PLANNING, ZONING, & BUILDING DEPARTMENT
PZ&B Staff Memorandum: Architectural Commission (ARCOM)

SUBJECT: ZON-24-0020 (ARC-24-0034) 336 AUSTRALIAN AVE W ^{WRB}

MEETING: JULY 24, 2024

PROPOSED SITE PLAN RENDERING

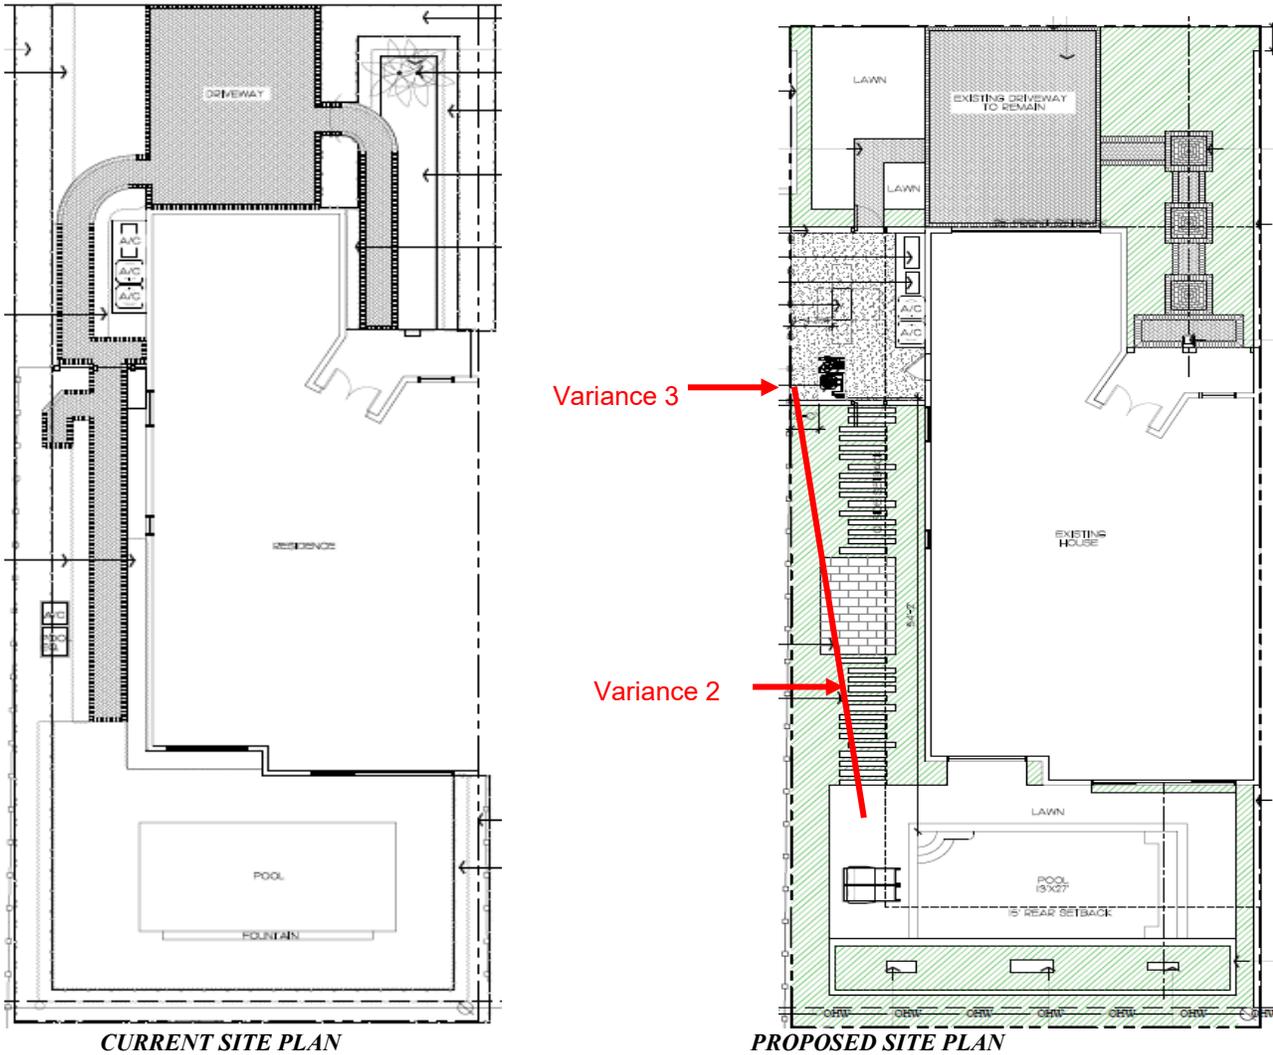
A preliminary review of the project indicates that the application, as proposed, is inconsistent with the Town zoning code and requires three (3) variances.

Code Section	Required	Proposed	Variance
Variance 1: Section 134-948	45% overall open space	36.35% LOS	8.65%
Variance 2: Section 134-1728(c)	Pool equipment @ 25'	54'-2"	29'-2"
Variance 3: Section 134-1728(c)	10' setback pool heater	3'	7'

The applicant is proposing renovations to hardscape and landscape to half of an attached duplex parcel, including the relocation of mechanical and pool equipment, which will require variances related to setback and distance separations. Additionally, the applicant is proposing to modify more

than 50% of the existing landscape open space area. The zoning code requires that landscape open space calculations be brought up to current requirements if altering 50% of the existing landscape area. Although the applicant is proposing an improvement from existing conditions (36.35% proposed in lieu of the 26.74% existing), a variance is required for failure to meet the 45% minimum required. Although the applicant is proposing an improvement from existing conditions (36.35% proposed in lieu of the 26.74% existing), a variance is required for failure to meet the 45% minimum landscape open space required.

The proposed pool equipment location is within the required setback (variance #3) and spaced further than permitted from the edge of the water (variance #2).
